12NPR 04-03-14-1 Reason For Revision

SECTION 42G: GTR200 COM-INTERCOM

FIGURE 1: SL-40 BNC

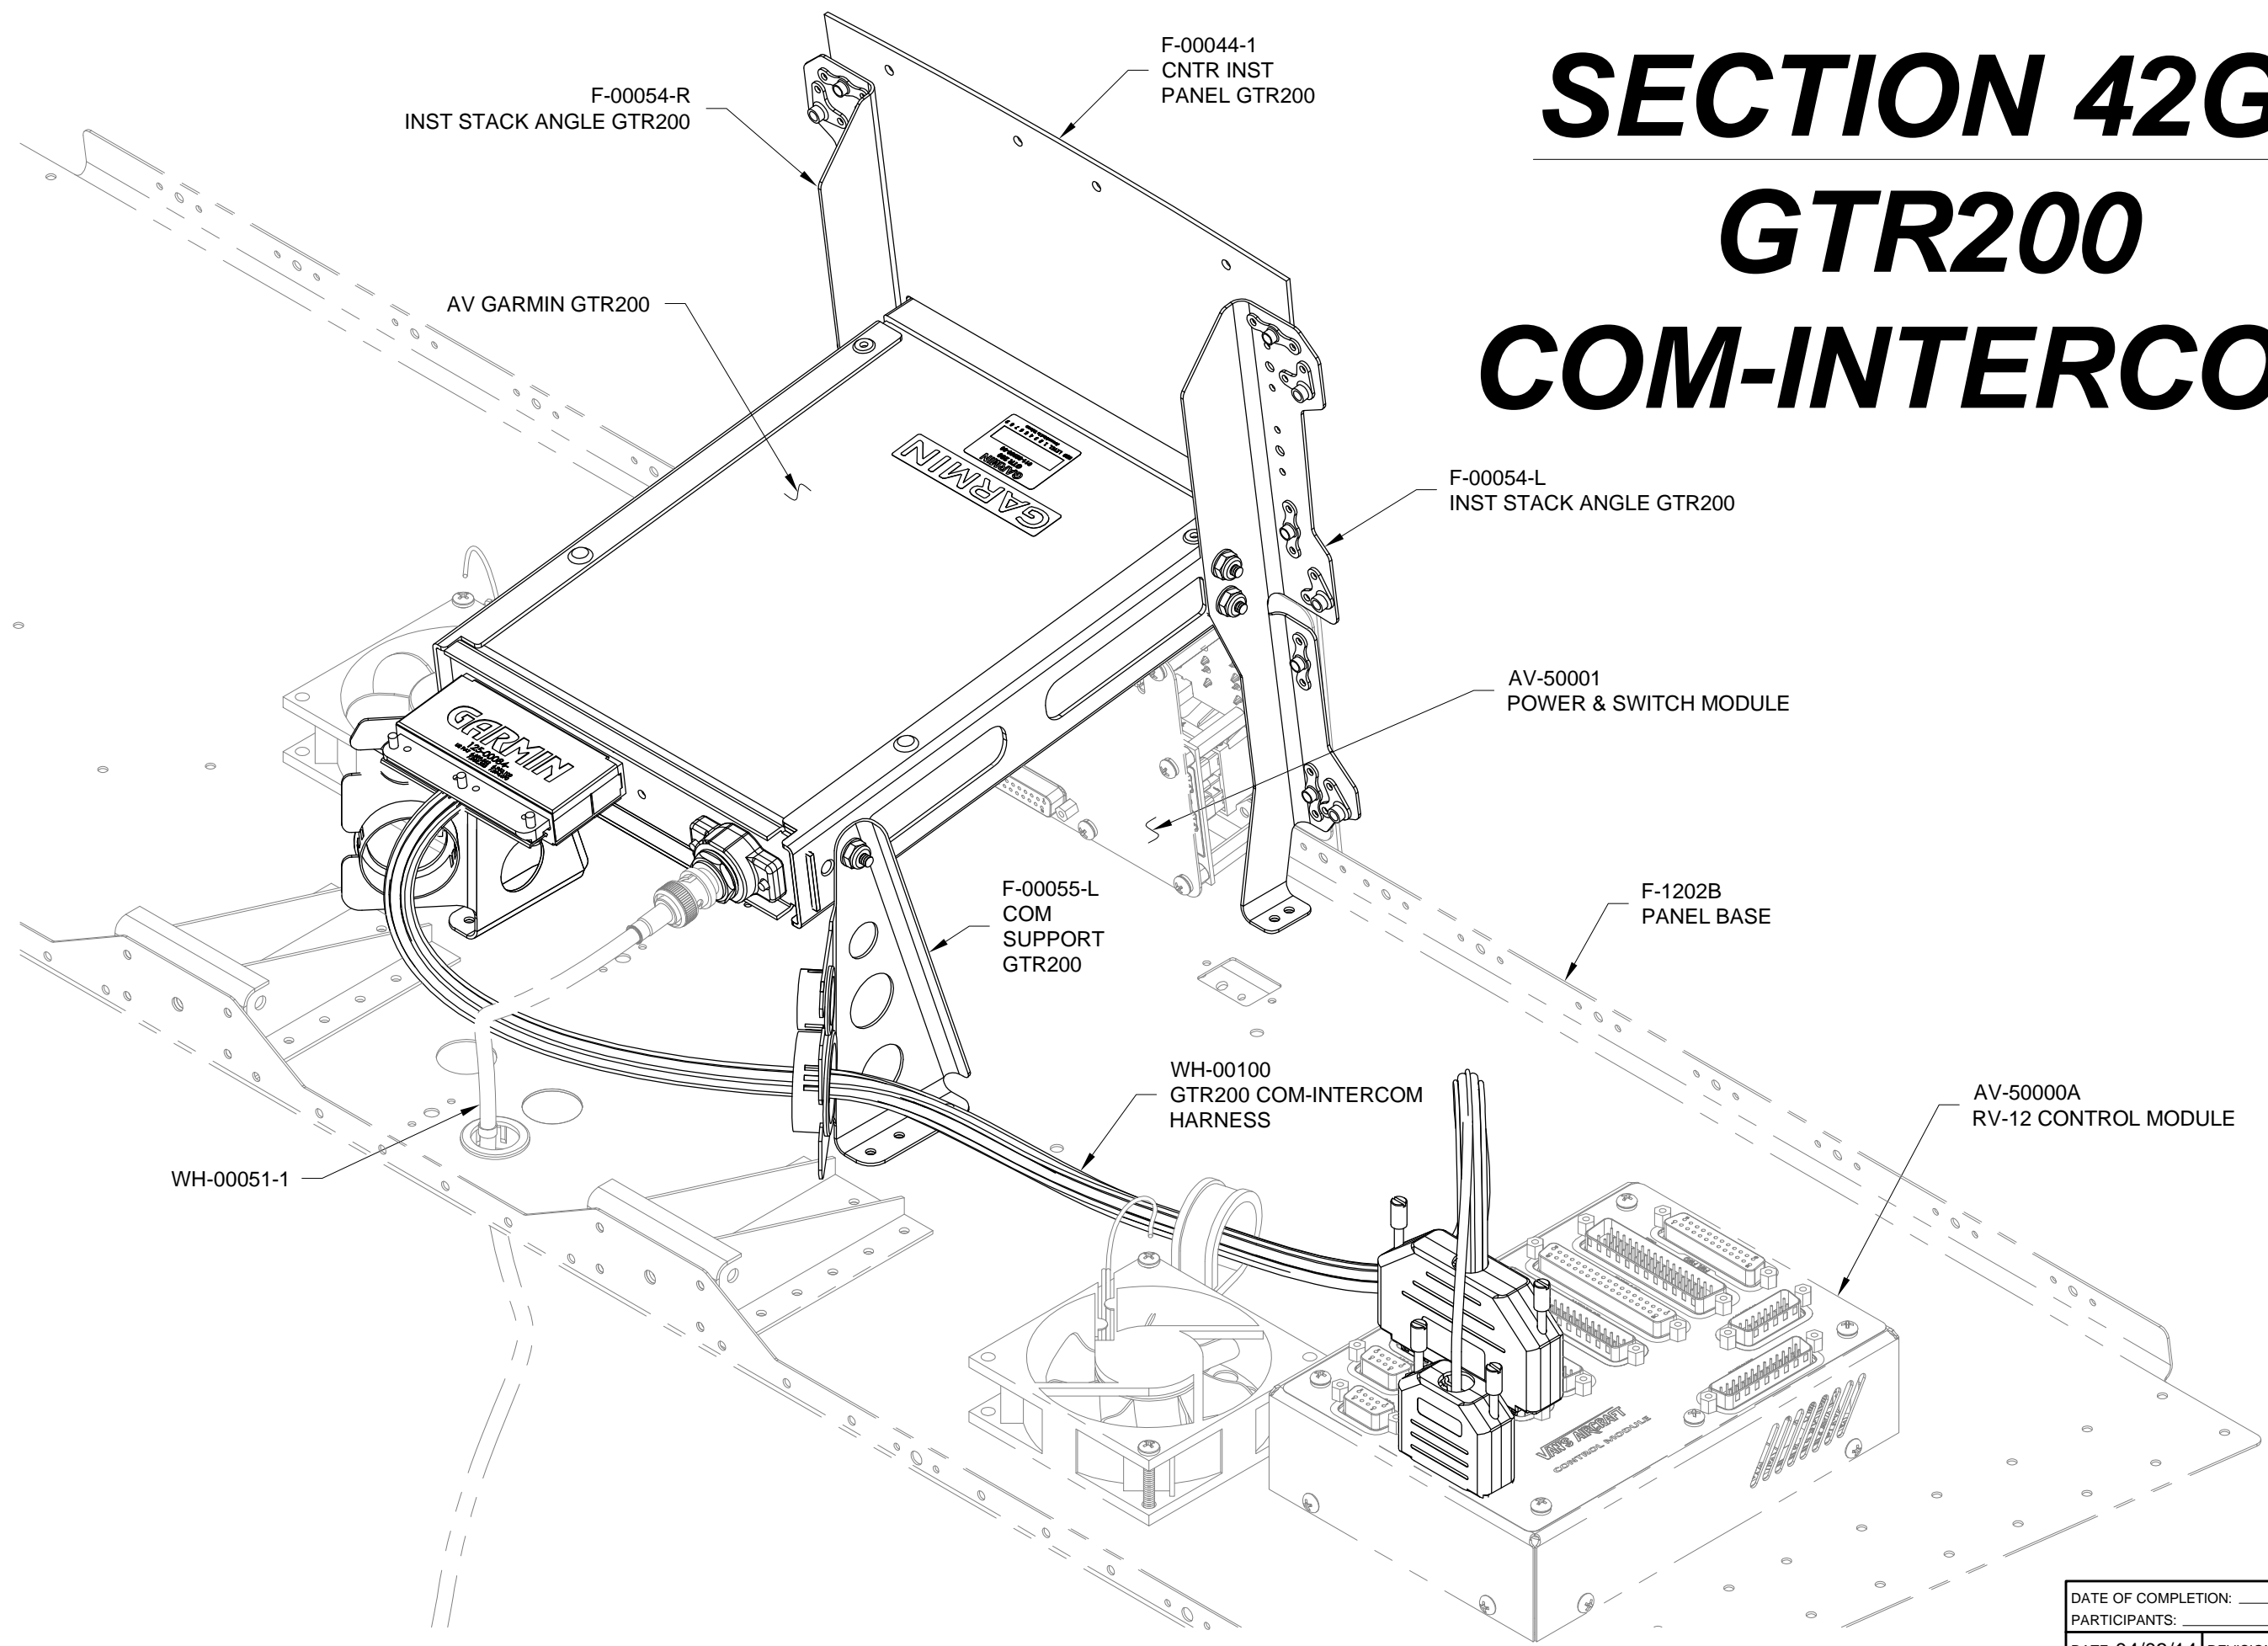
Also add **"NOTE: Older finish kits were shipped with a SL-40 specific COM antenna cable connector. Connectors as shown in Figure 1 will need to be cut off and replaced with "AV BNC 1039-ND" available from Vans Aircraft. This requires a BNC RG 58 crimping tool for a wire cross section of .213". We recommend a Proskit CP-371 using CP-336DI."**

NOTE: Older finish kits were shipped with a SL-40 specific COM antenna cable connector. Connectors as shown in Figure 1 will need to be cut off and replaced with "AV BNC 1039-ND" available from Vans Aircraft. This requires a BNC RG 58 crimping tool for a wire cross section of .213". We recommend a Proskit CP-371 using CP-336DI.

**FIGURE 5:
PANEL AND BRACKET INSTALL**

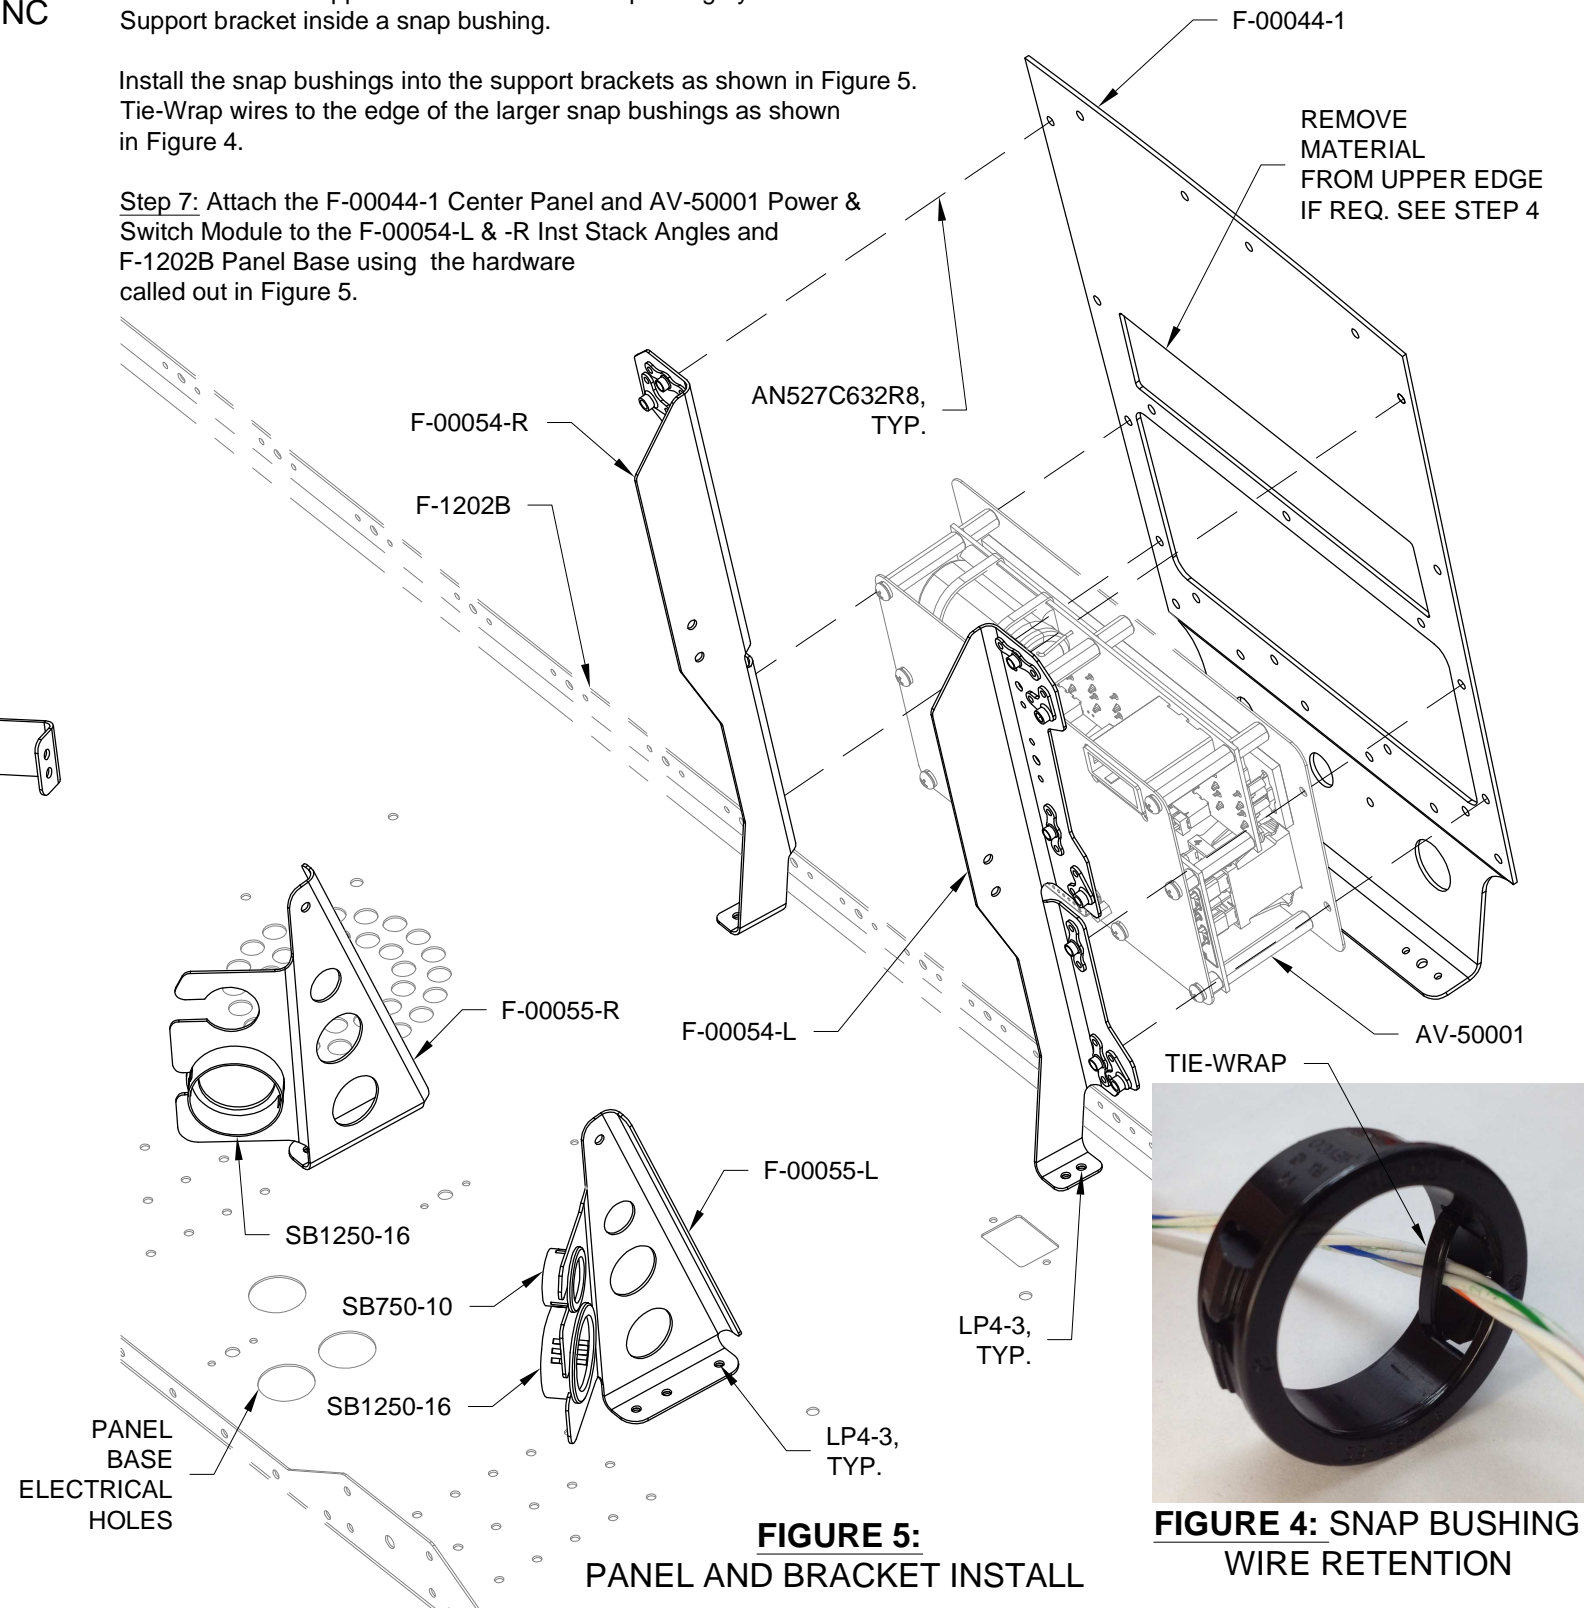
In Step 1,4, 7 and Figure 5 "F-00044-1" was "F-00044"

Step 7: Attach the F-00044-1 Center Panel and AV-50001 Power & Switch Module to the F-00054-L & -R Inst Stack Angles and F-1202B Panel Base using the hardware called out in Figure 5.

FIGURE 1:
INSTALLATION OVERVIEW

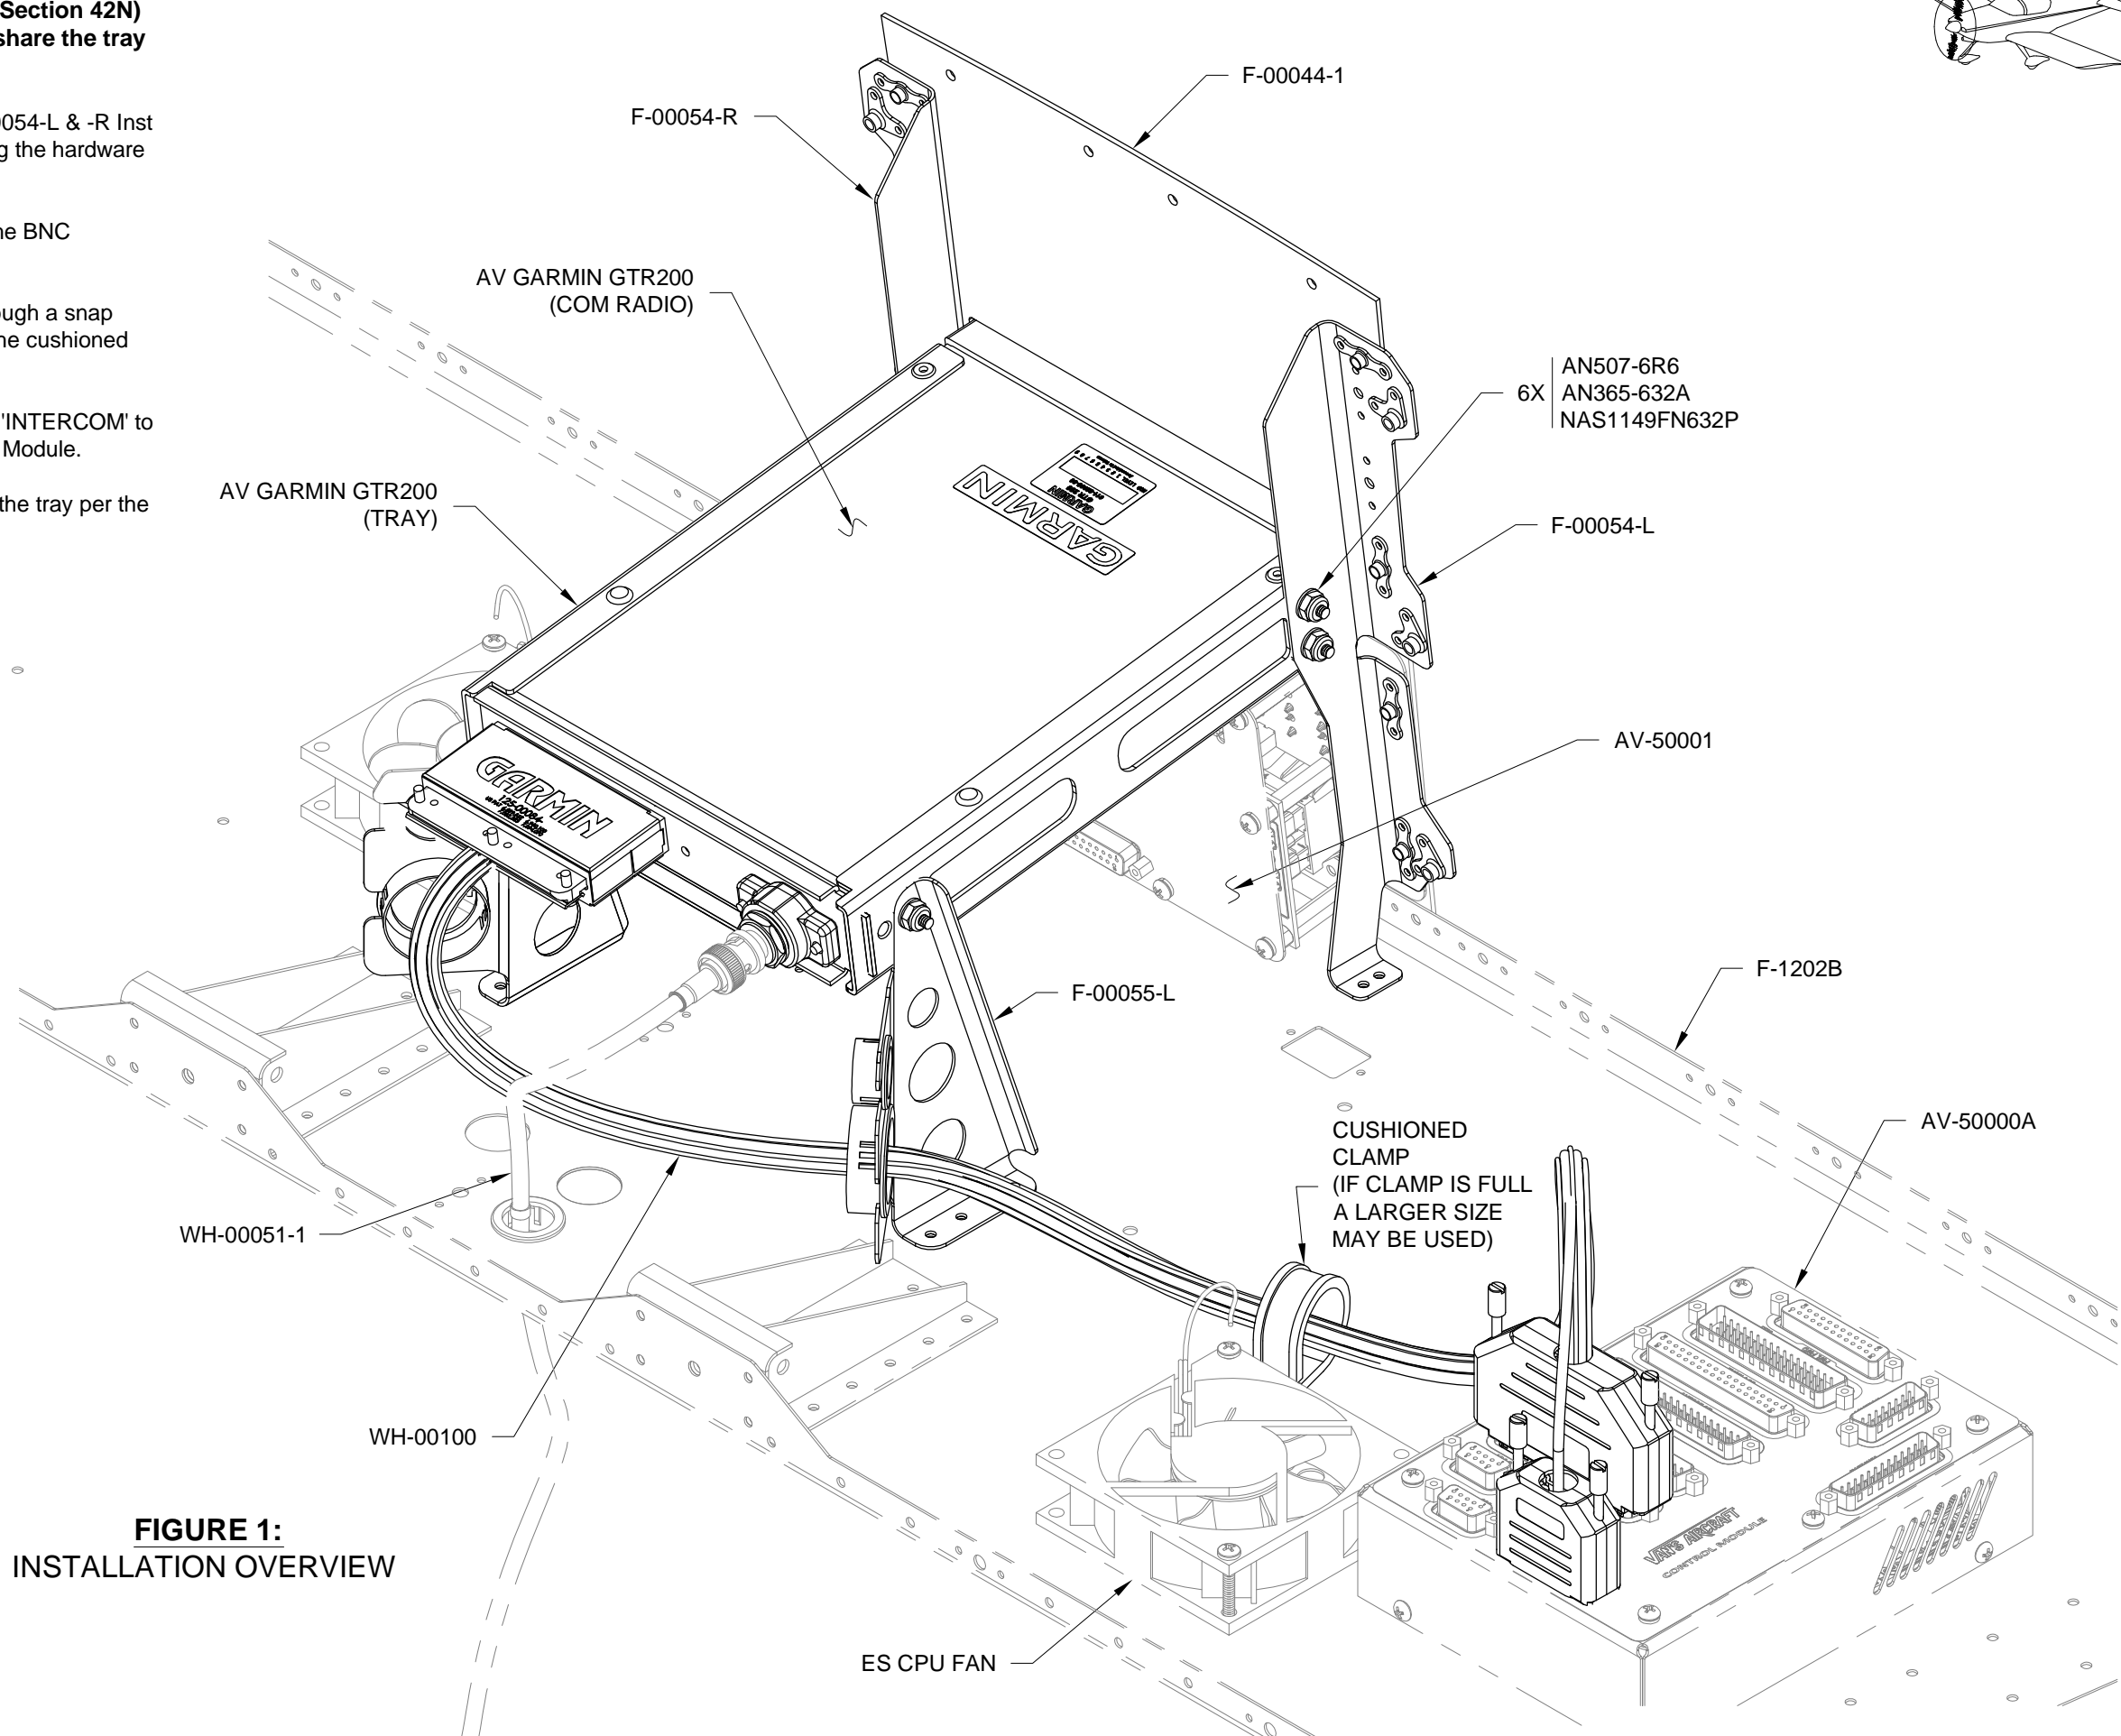
KAI Page 42G-03 REV 1: Add note at beginning of page **"NOTE: If installing a G3X Touch EFIS system (See Section 42N) or SkyView ADS-B (See Section 53) brackets will share the tray attach screws.**

In Figure 1 "F-00044-1" was "F-00044"

NOTE: If installing a G3X Touch EFIS system (See Section 42N) or SkyView ADS-B (See Section 53) brackets will share the tray attach screws.
